SERVICE BULLETIN 00058

Subject: HIC Module Replacement

Affected Models: RV-12iS with Avionics Kits shipped before August 2022

Required Action: Replace AV-60009 or AV-60009-1 with AV-60009-2

FIGURE 1: ROTAX ECU REMOVED FROM F-01202B-1 PANEL BASE

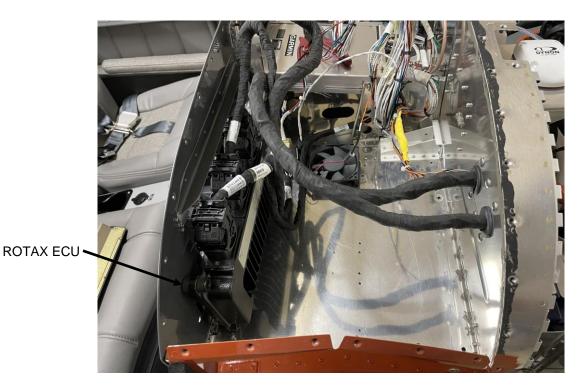
<u>Step 3:</u> Cut all zip ties restraining the ROTAX ECU harness. Remove the fasteners and move the ROTAX ECU out of the way as shown in Figure 1.

FIGURE 2: TOOL-00114 INSTALLED ON F-01202B-1 PANEL BASE

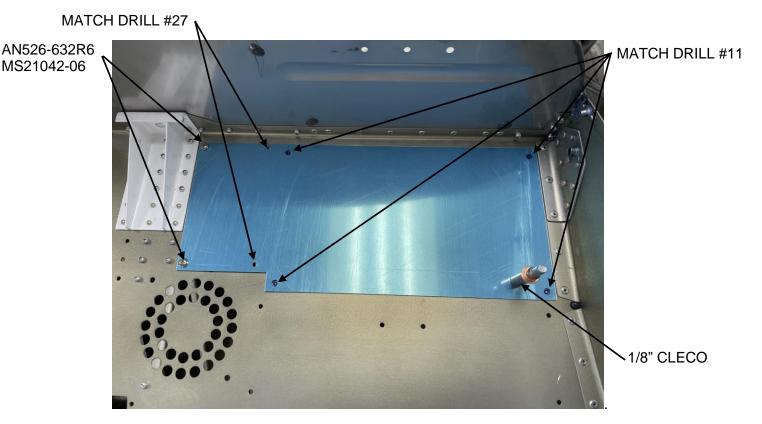
<u>Step 4:</u> Place TOOL-00114 drill template onto the F-01202B-1 Panel Base and fasten using hardware noted in Figure 2. Match-Drill as shown in Figure 2. The #27 holes are overlapping with existing holes to create a slot. After drilling, some additional filing may be required to fit the AV-60009-2.

FIGURE 4: ATTACHING WIRES TO HIC MODULE

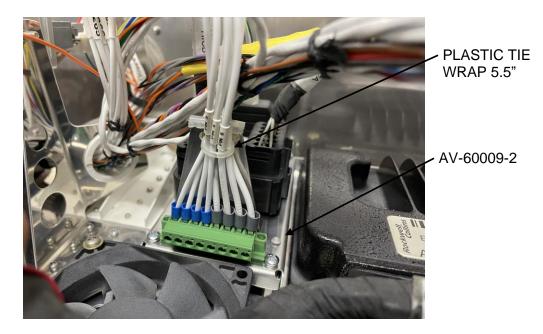
<u>Step 11:</u> Attach all wires to the HIC Module and install a PLASTIC TIE WRAP 5.5" for strain relief between the wires and the F-12335 HIC Harness Strain Relief. Refer to Figure 4, and KAI 42MiS/U-13 or 42MiS/U-41.
